Market Announcement

Invotech Scroll Technologies Co.,LTD

For better applicability of InvoTech products, we have made the following changes to compressors of 5 HP, 6HP, 10HP platform to protect compressors

1. YM Series Compressors adding discharging temperature thermostat protecting

Installation guide

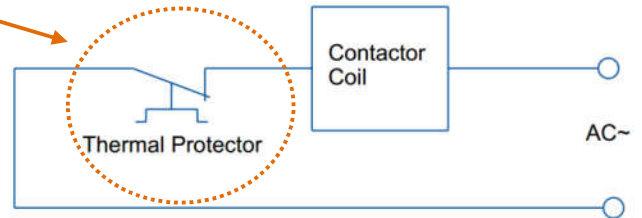
- ① Changing reason:
To protect compressors in the case of high running discharging temperature
- ② Involving platform:
5HP, 6HP, 10HP platform
- ③ Involving models:
YM34***_****~YM210***_****

HPT temperature control switch:
Operating limits:
250V, 7A

1. 将温控开关导线穿过防护塞中心孔
2. 温控开关插入温控套管底部
3. 防护塞插入温控套管

1. Temperature switch leads through the hole of the plug.
2. Temperature switch inserted into thermostat tube.
3. Plug insert thermostat tube.

Thermostat Specification:

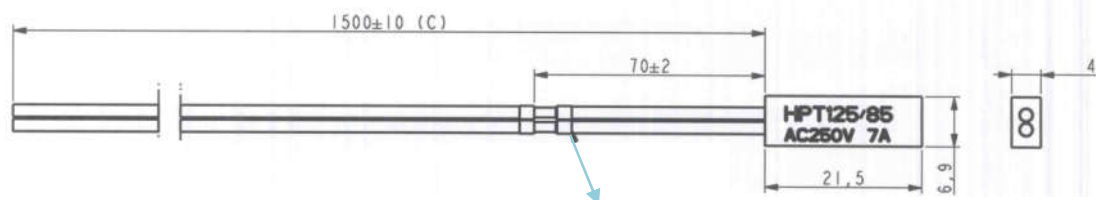
Cut out temperature (°C)	Reset temperature (°C)	Rated voltage (VAC)	Rated current (A)	Frequency (Hz)	Wire specification (AWG)
125±5	85±10	250	7	50/60	20

Heat-shrinkable tubing
